Docket Nos. 50-259
50-260
and 50-296

The Commission has issued the enclosed Amendments Nos. 44, 40 and 17 to Facility Licenses Nos. DPR-33, DPR-52 and DPR-68 for the Browns Ferry Nuclear Plant, Units Nos. 1, 2 and 3. These amendments consist of changes to the Technical Specifications in response to your requests of August 2, 1978 (BFNP TS 112) and August 11, 1978 (BFNP TS 114).

BROWNS FERRY NUCLEAR PLANT, UNIT NO. 1

AMENDMENT TO FACILITY OPERATING LICENSE

Figure 4.2-1

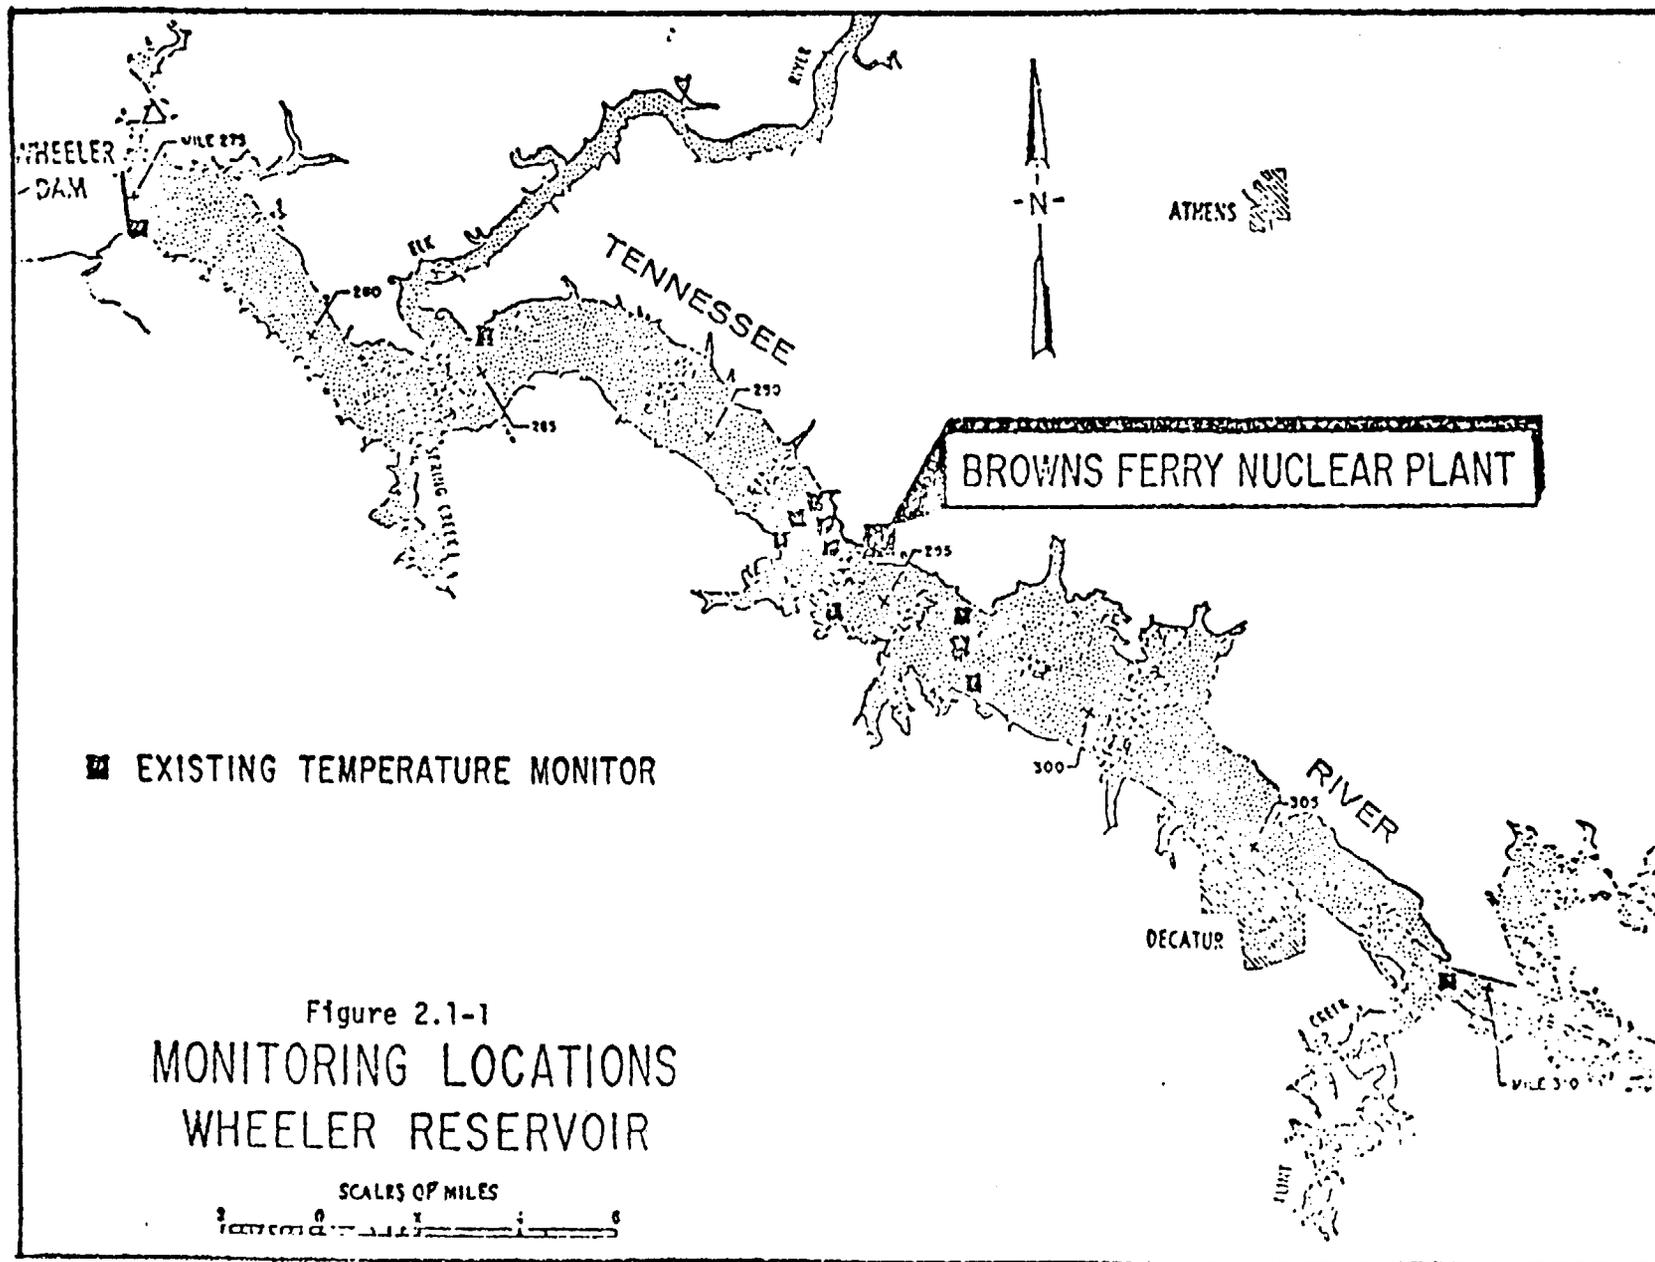
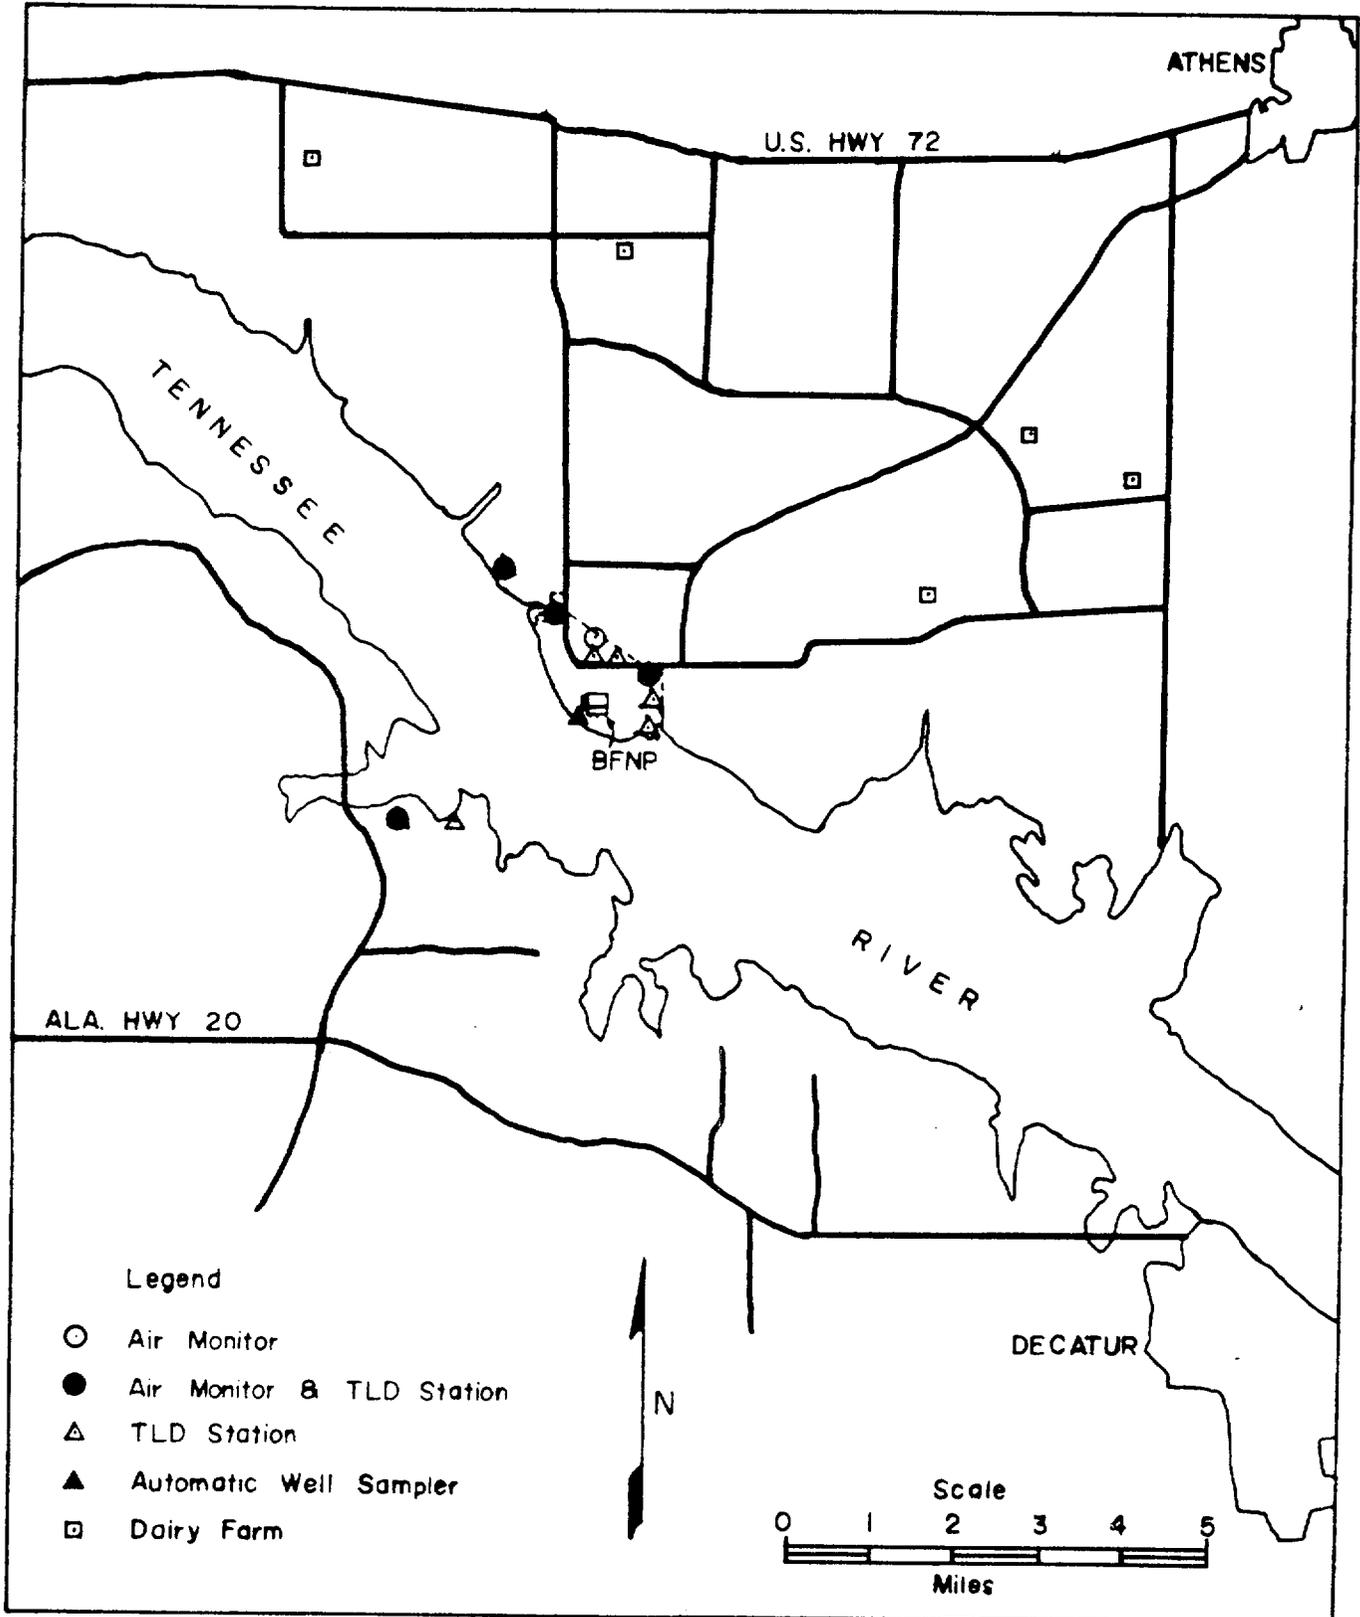
As part of the environmental radiological monitoring program at the Browns Ferry Nuclear Plant, TVA collects and analyzes a number of samples. The Browns Ferry Nuclear Plant Environmental Technical Specifications state that "milk shall be collected....from at least four farms in the vicinity of the plant..." and that"...any location from which milk can no longer be obtained may be dropped from the surveillance program. The NRC shall be notified in writing that milk-producing animals are no longer present at that location. An additional milk sampling location will then be added to the program..." (Section 4.2.3.b).

As of May 15, 1978, milk is no longer available from the dairy farm located approximately four miles north of Browns Ferry Nuclear Plant. The milk producing animals have been sold and removed from the farm. A dairy farm located approximately five miles north of the plant has been added to the monitoring program.

We have reviewed the meteorological data and deposition factors for the Browns Ferry plant and conclude that the new sample location is acceptable.
